MXD INFILL DEVELOPMENT CONCEPT PLAN

RESPONSE TO COMMENTS

CAMBRIDGE, MASSACHUSETTS
ISSUED NOVEMBER, 2016

IDCP RESPONSE TO COMMENTS

FIGURE R10.1.1E

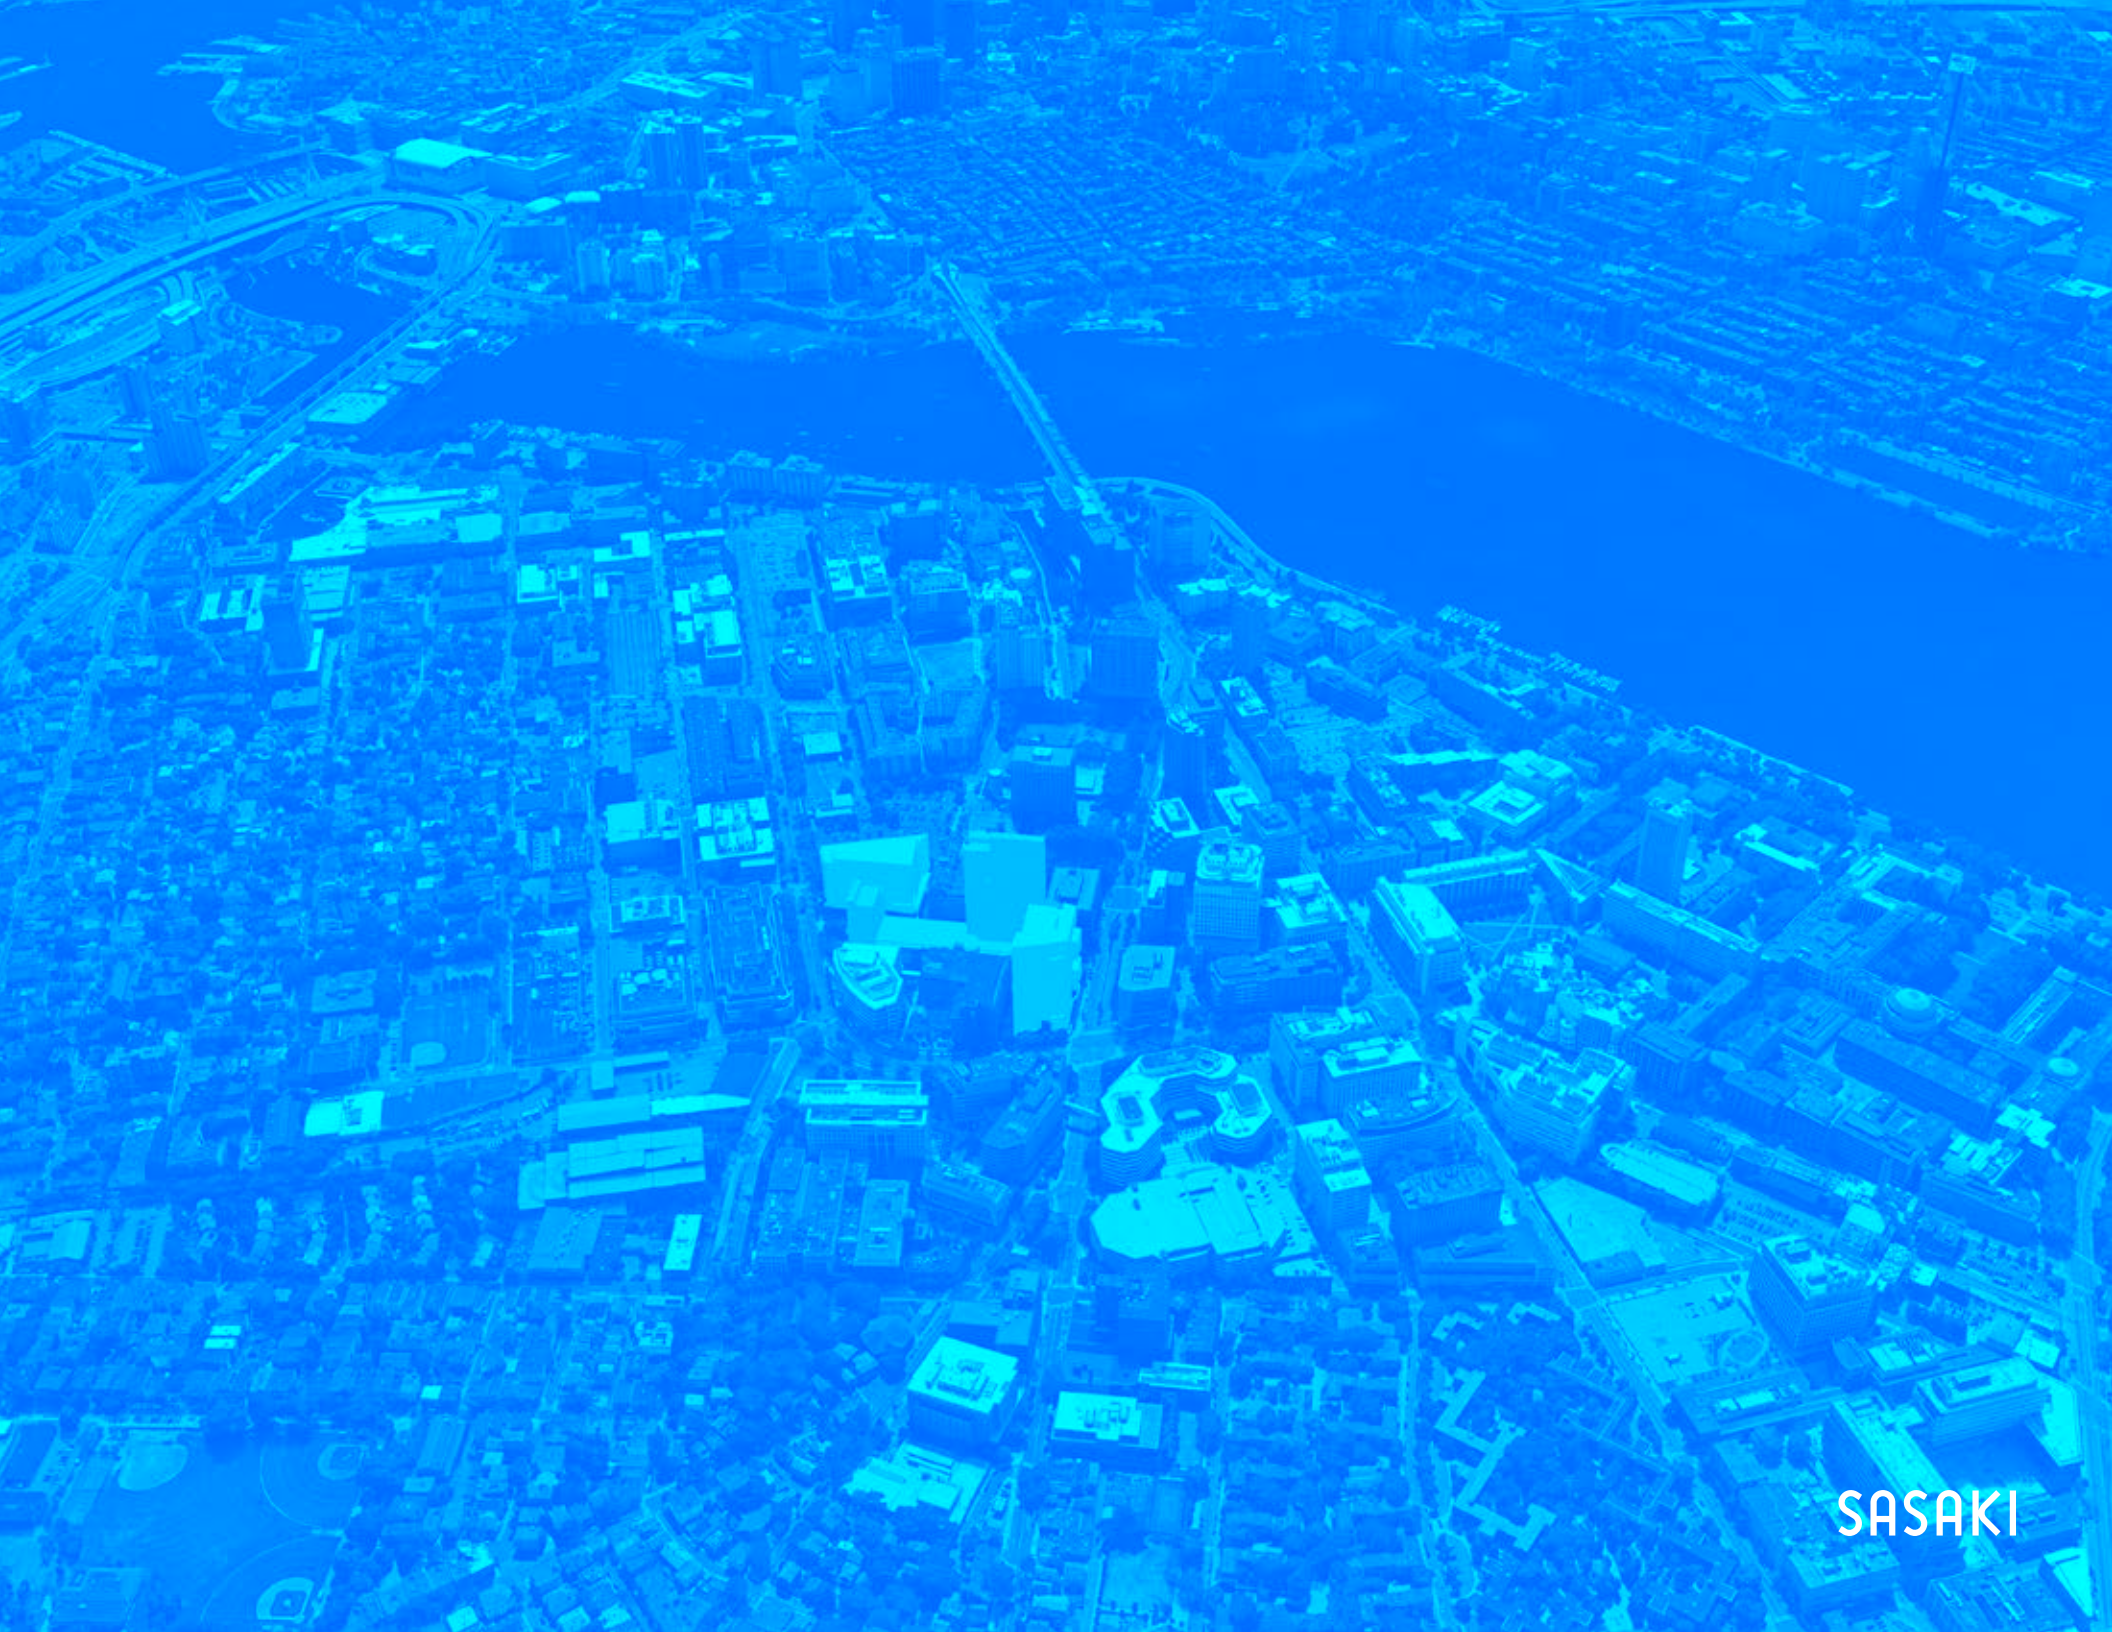
R10.1.1 DESIGN GUIDELINES: CDD staff has requested the addition of more information about the architectural and urban design character of the building façade treatments.
